MEMORANDUM

TO: PLANNING COMMISSION
FROM: EVAN C. GARIEPY – PLANNER
SUBJECT: REQUEST FOR VARIANCE #V1-2026 TO REDUCE FRONTAGE TREE SCREENING REQUIREMENTS AND TO PERMIT PLANTING TREES WITHIN AN EASEMENT ON LOTS 4 AND 5, BLOCK 2, NEW PRAGUE BUSINESS PARK 11TH ADDITION.
DATE: FEBRUARY 19TH, 2026

GRADING, DRAINAGE & EROSION CONTROL PLAN
NEW PRAGUE COMMERCIAL BUILDING
CITY OF NEW PRAGUE

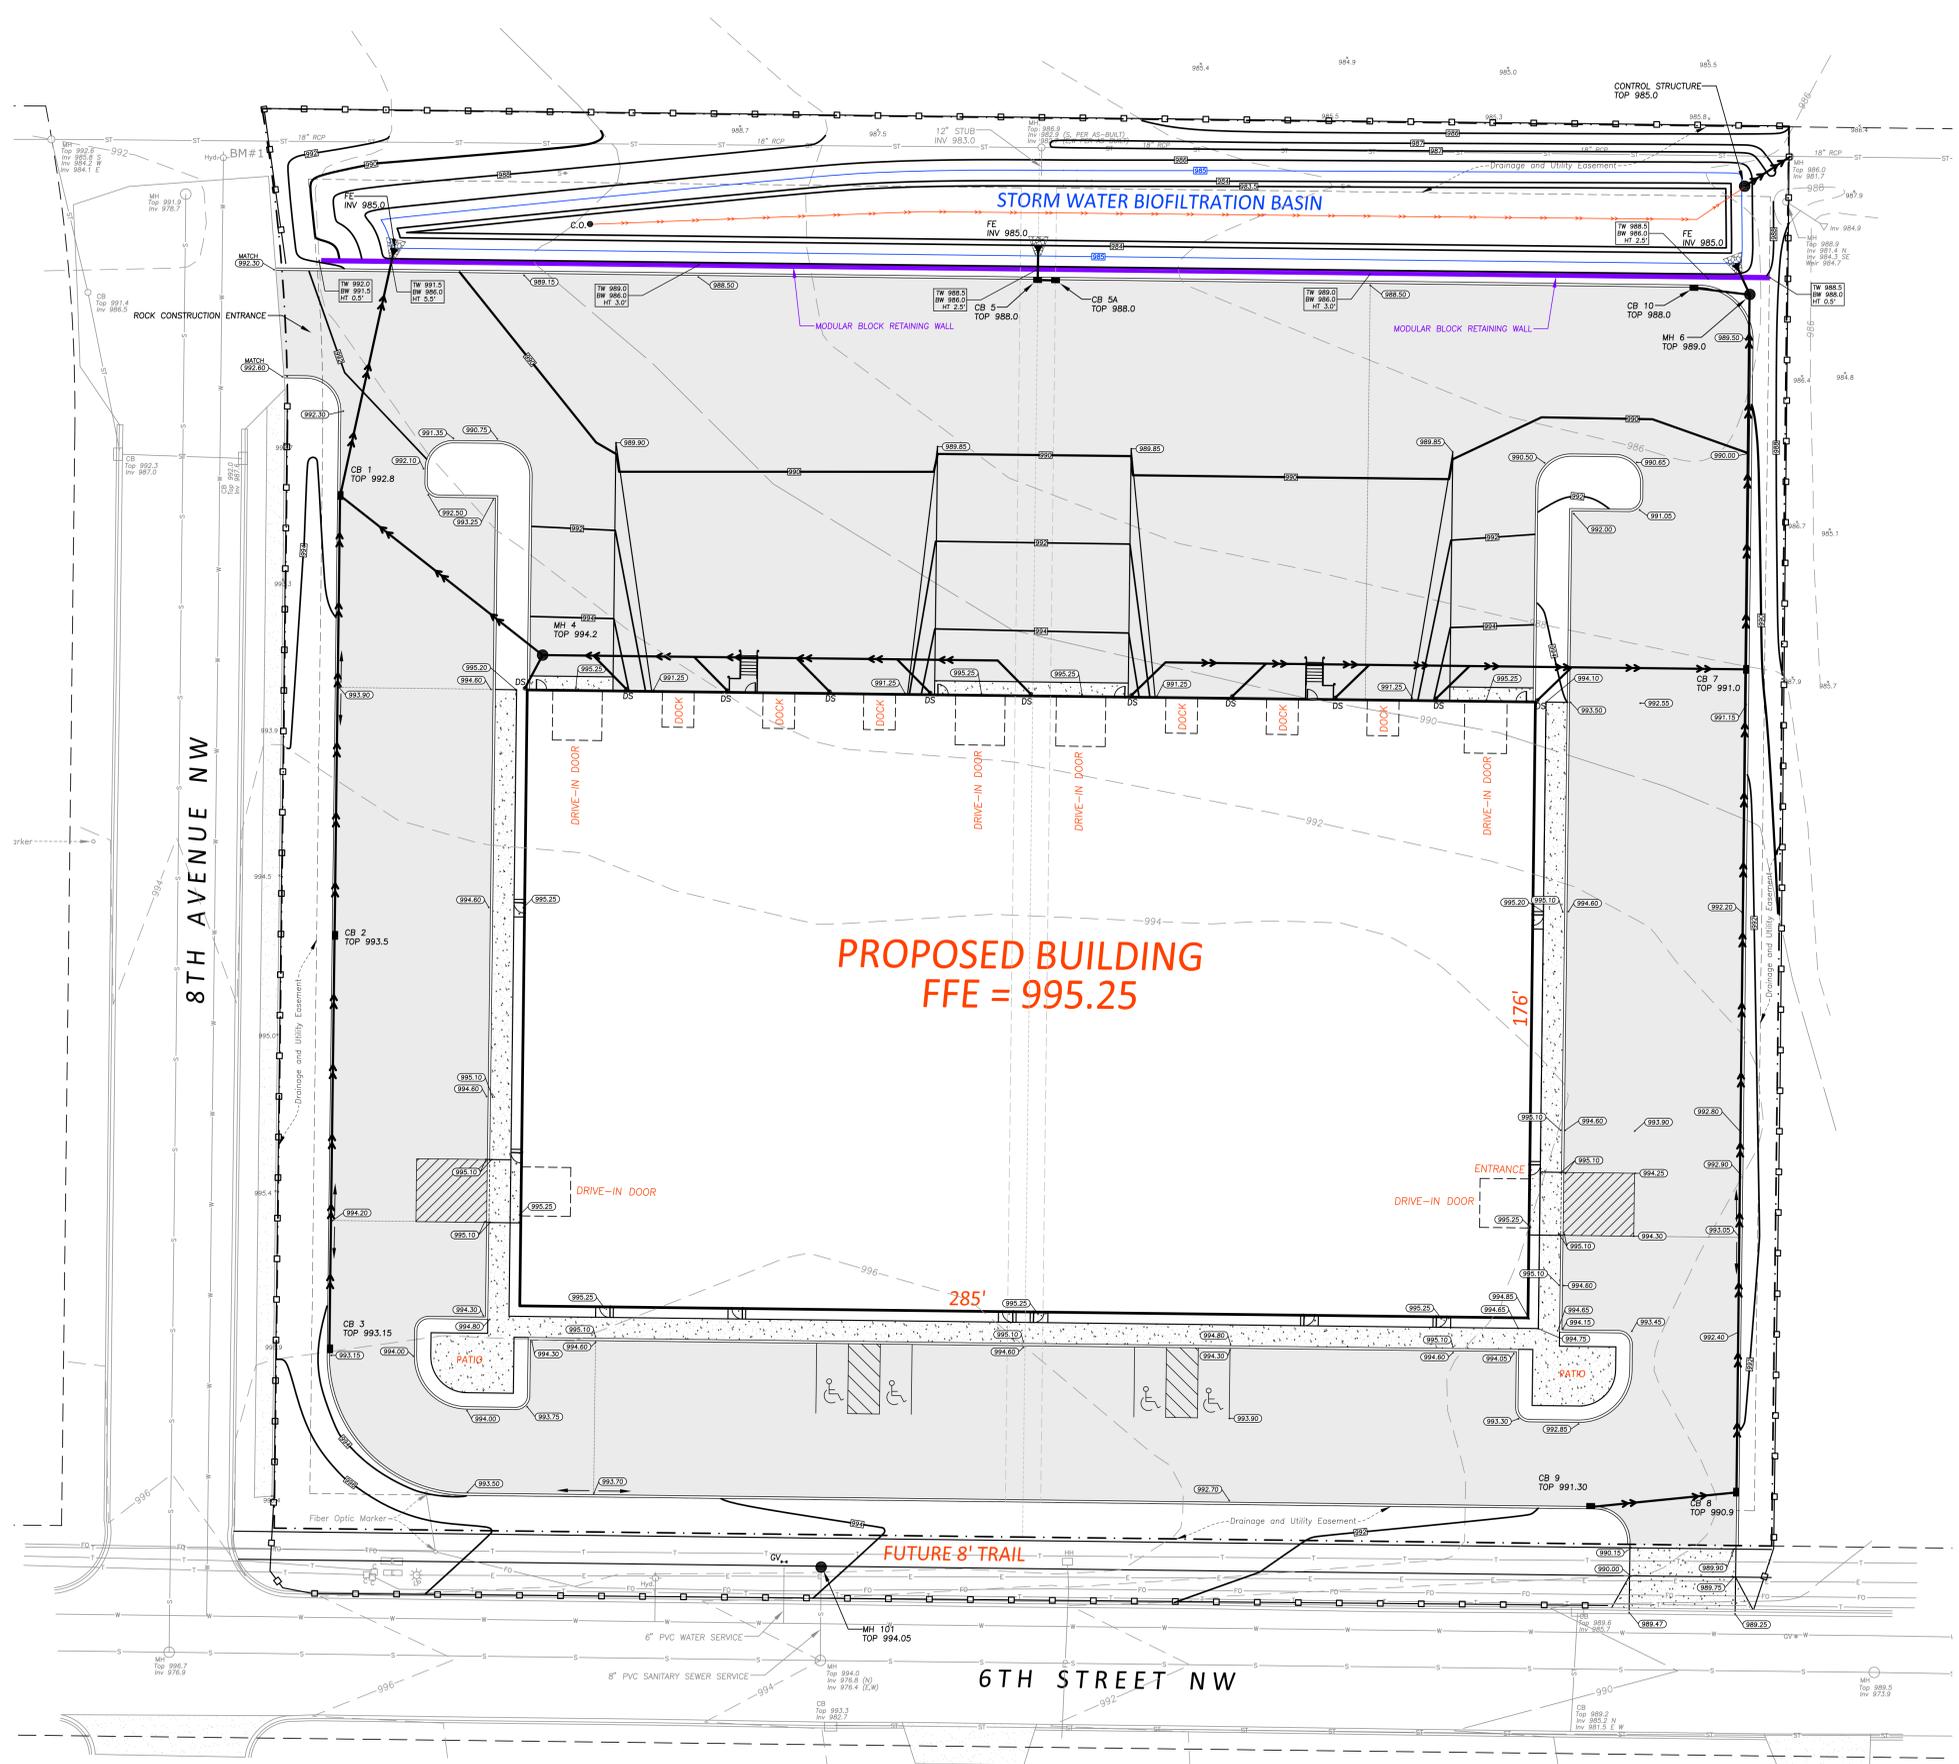
- 1. The developer will grade the south right-of-way to accommodate the future trail.
- 2. A grading plan will be provided prior to approval of a variance.

- G. The following additional conditions are to be imposed:
 - a. The developer must grade the south right-of-way to accommodate a future trail.
 - b. A grading plan must be provided prior to the approval of this variance.
